# Engineering Department Memorandum

**To :** Kevin Driscoll, P.E. Village Engineer  
**From :** Brad Seubert, P.E. Harwood Engineering Consultants  
**Date :** December 12, 2023  
**Re :** Truck Country

## **Items Reviewed:**

1. Civil Plan Set Dated: 11-13-2023
2. Stormwater Management Plan Dated: 11-13-2023

SITE GRADING PLAN  
**C-102**

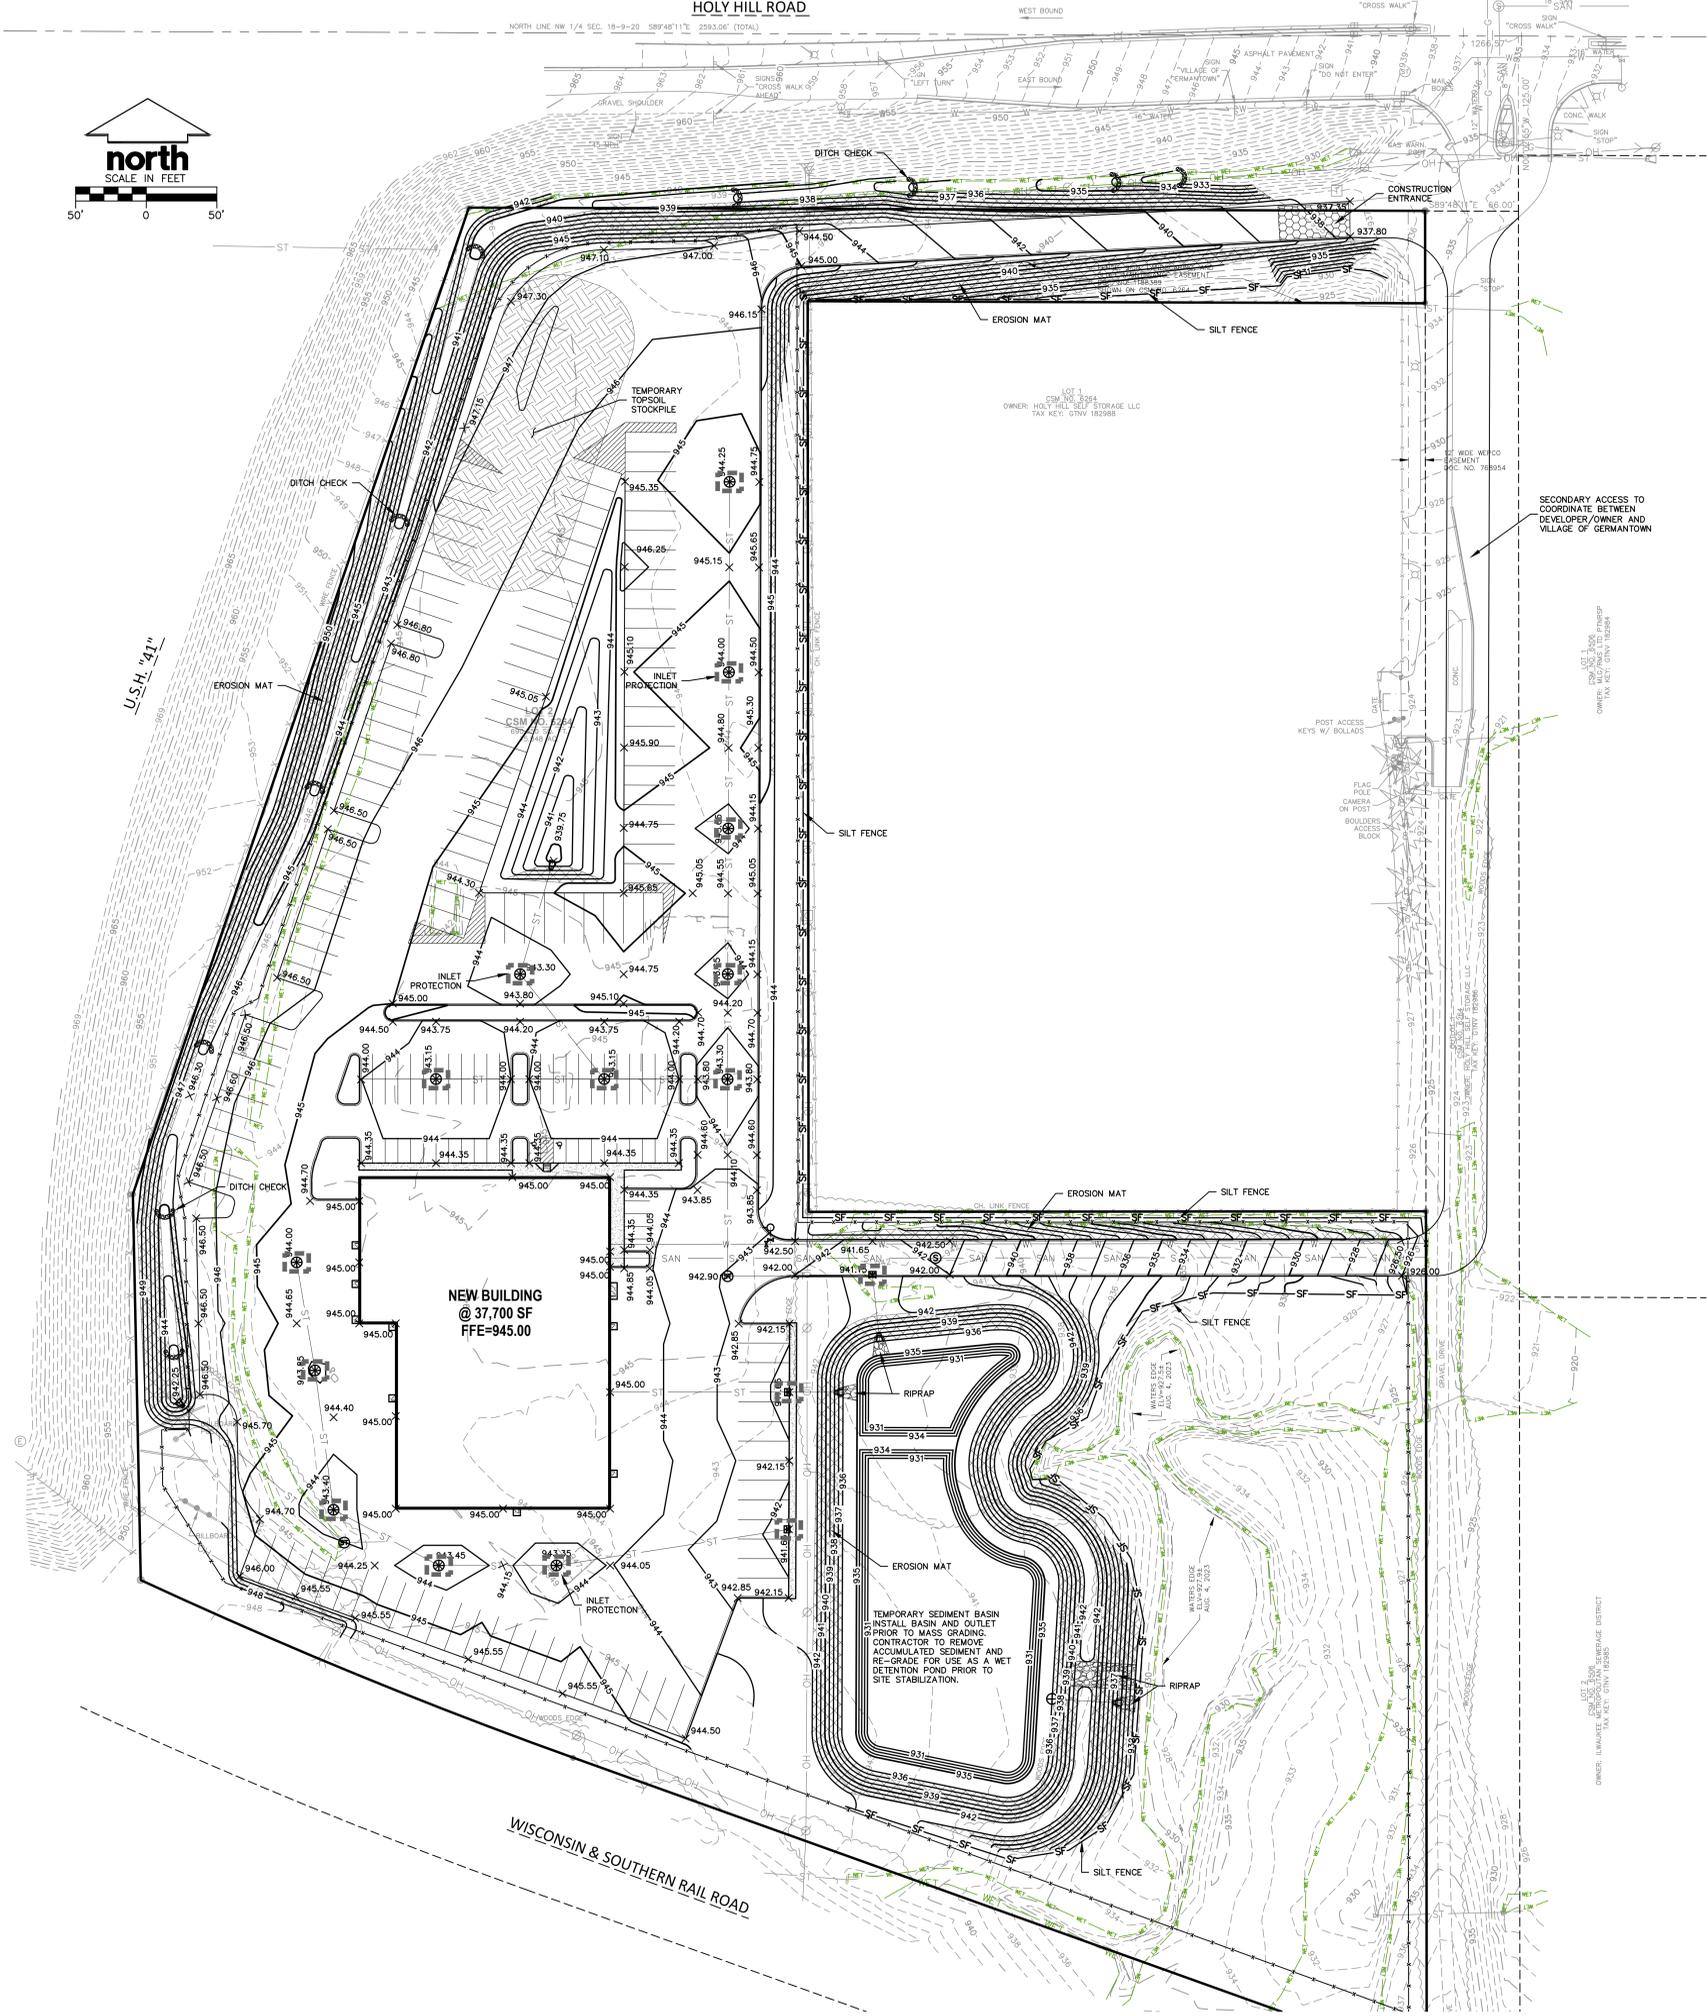
1. Revise note 10 to require disturbed areas that will remain inactive for 14 days or longer to be stabilized.

SITE UTILITY PLAN

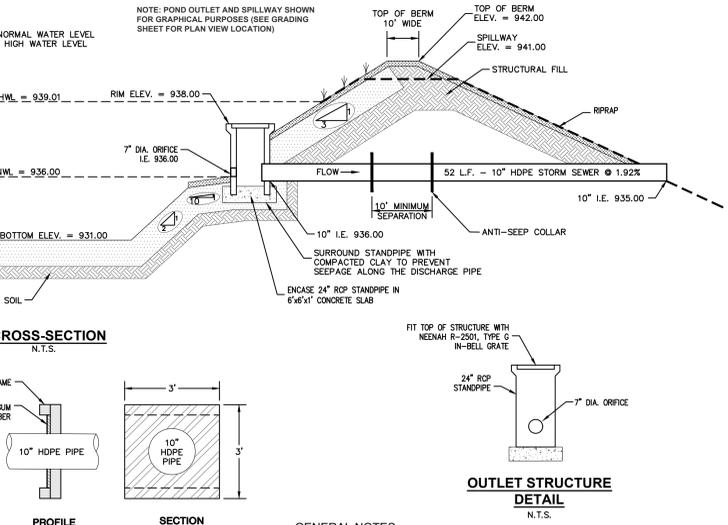
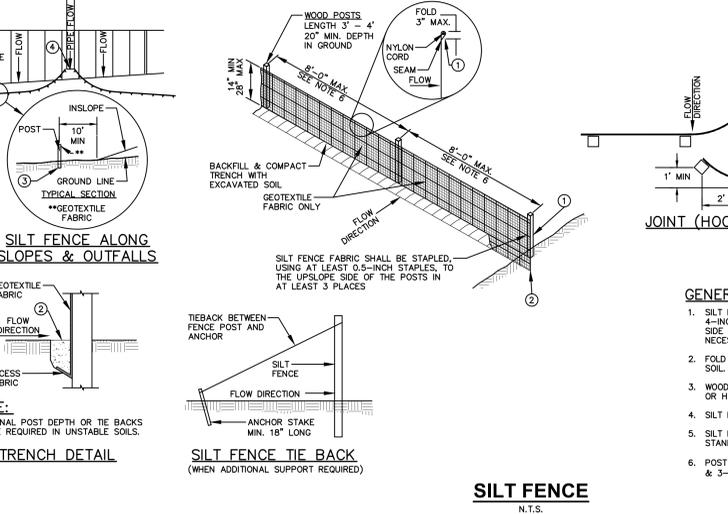
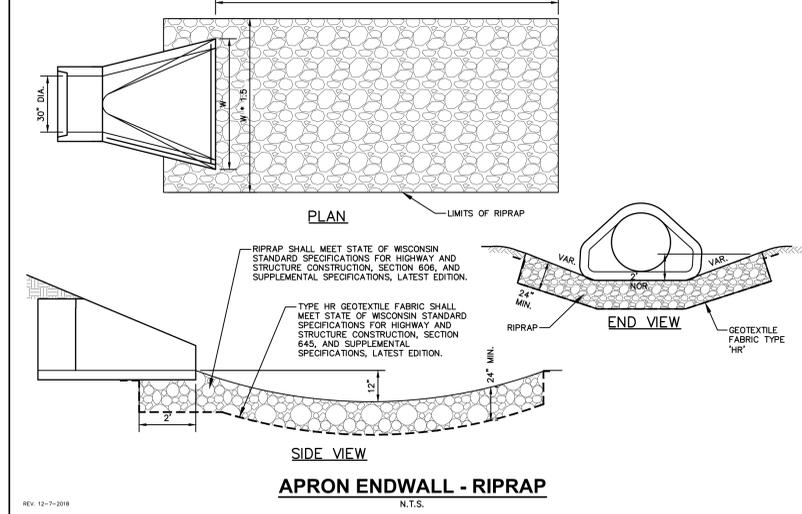
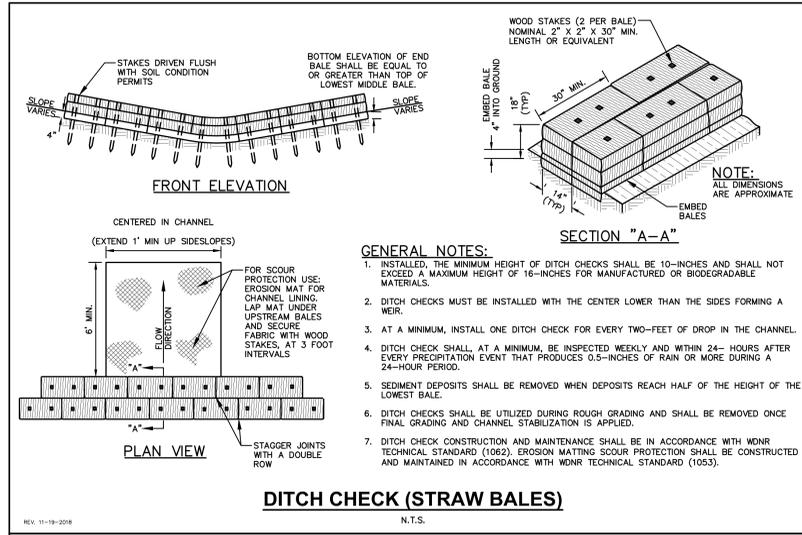
1. Where does the existing line shown going east out of ST-30 drain to?
